**SEAS REBUTTAL TO NGET'S PROPOSED WORKS TO BENHALL RAILWAY
BRIDGE [REP4- 101] & ASSOCIATED ACCESS**

SEA LINK: EN020026

DEADLINE: 5 – March 10, 2026

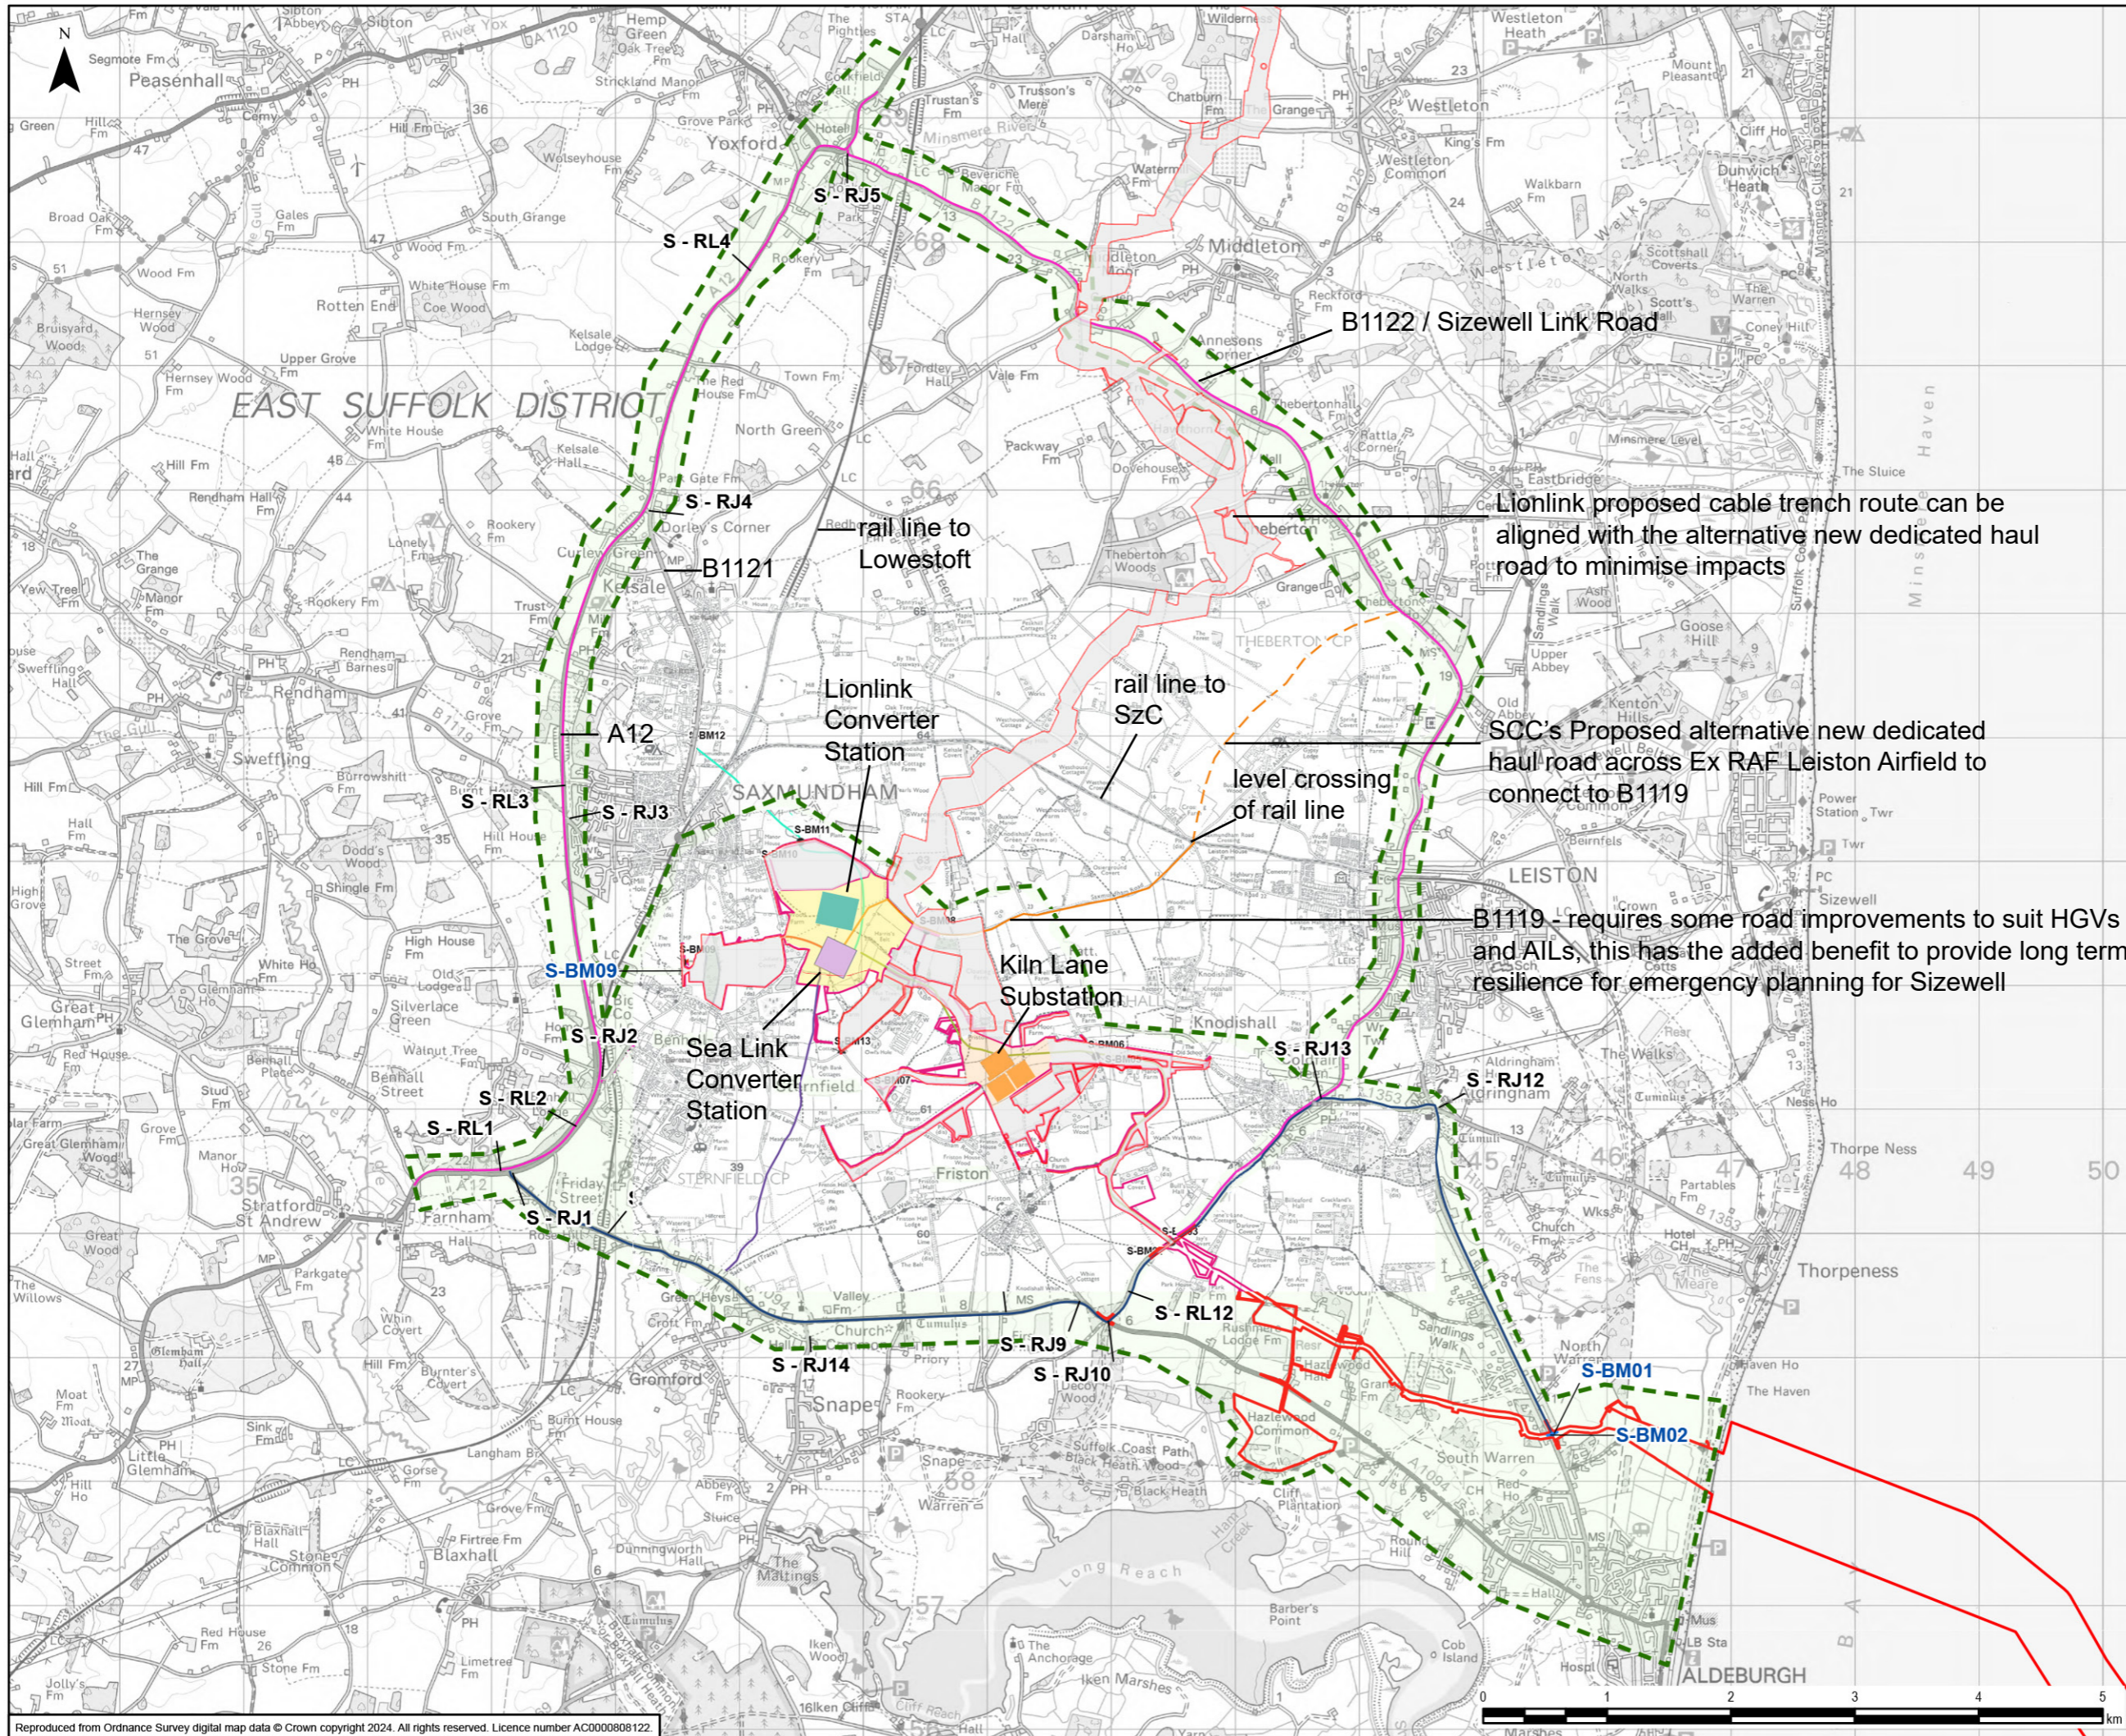
Lionlink proposed cable trench route can be aligned with the alternative new dedicated haul road to minimise impacts

SOC's Proposed alternative new dedicated haul road across Ex RAF Leiston Airfield to connect to B1119

B1119 - requires some road improvements to suit HGVs and AILs, this has the added benefit to provide long term resilience for emergency planning for Sizewell
